PRODUCT CHANGE NOTIFICATION (PCN)

A-MCSSP60010/Y MODULAR CABLE

CHANGE NOTIFICATION: PCN 20220822_A-MCSSP60010/Y

DESCRIPTION OF CHANGES: CHANGE OF DATA SHEET
CHANGE OF DATA SHEET
New Draw.-No. ASS_7542_CArev06

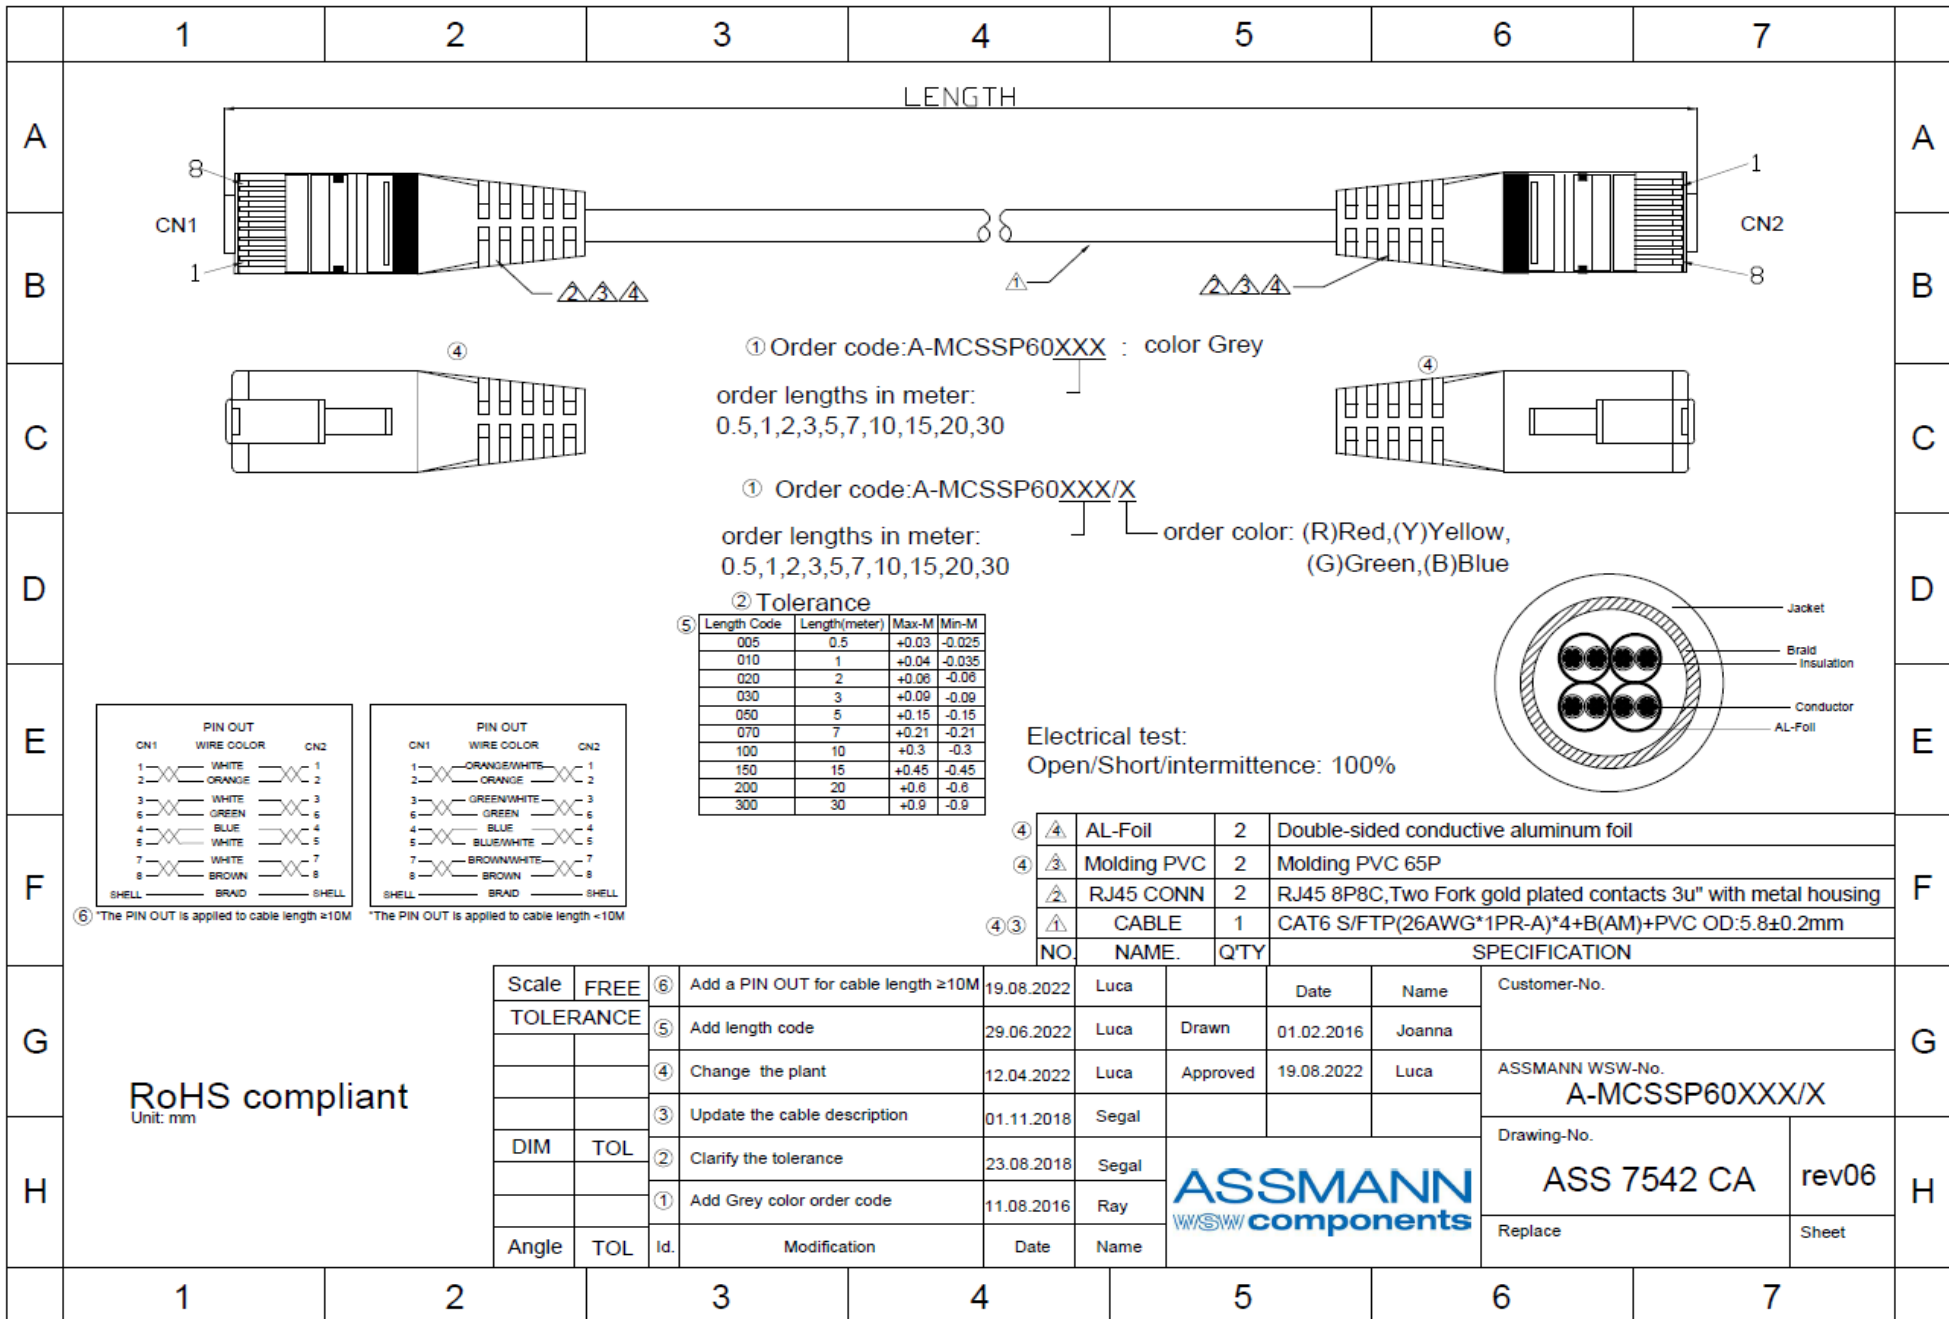
REASON FOR CHANGE: CHANGE OF MATERIAL PARAMETERS OR PROPERTIES
CHANGE OF MATERIAL PARAMETERS OR PROPERTIES

KEY CHARACTERISTICS OF CHANGE: Details see page 3
